CAMPAIGN BULLETIN

05-586-09

Models Affected: HR37 & HR40 Aerials

SUBJECT: Rod Weldment of 437250D Main Lift Cylinder

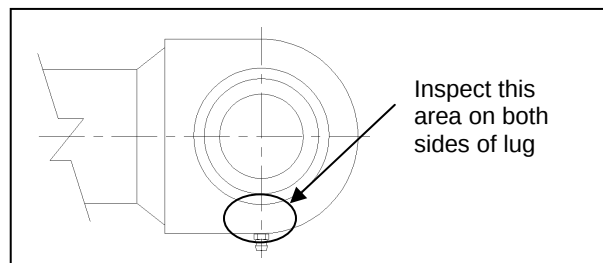
Terex Utilities has determined that material supplied for the lower boom lift cylinder rod eye on certain 437250 cylinders is not to specification and can fail. The supplier involved provided rod eye material used on HR37 or HR40 units built between 6/21/1999 through 1/30/2001.

If the cylinder rod eye fails the boom and platform will fall.

The owner or user must immediately perform a visual inspection of the cylinder rod eye in the area of the grease zerk. Clean off the dirt and grease to determine if a crack is evident near the ball bushing. If there are any indications of a crack remove the unit from service and contact Terex Utilities at 605-884-3892. If no cracks are detected contact the nearest Terex Utilities dealer to arrange replacement of the cylinder rod within 45 days. You may continue to use the unit if you inspect the rod eye daily to determine that no cracks are present.

Inspect Lift cylinder rod end in this area on both sides. Clean off dirt and grease to see side of lug down to the bushing bore.

Inspect this area on both sides of lug

Affected units, as shown on the owner letter, will have the cylinder rod replaced at no charge to the owner. Repair parts will be available beginning 5/15/09. All 437250D cylinder rods with the date codes listed above will be replaced.
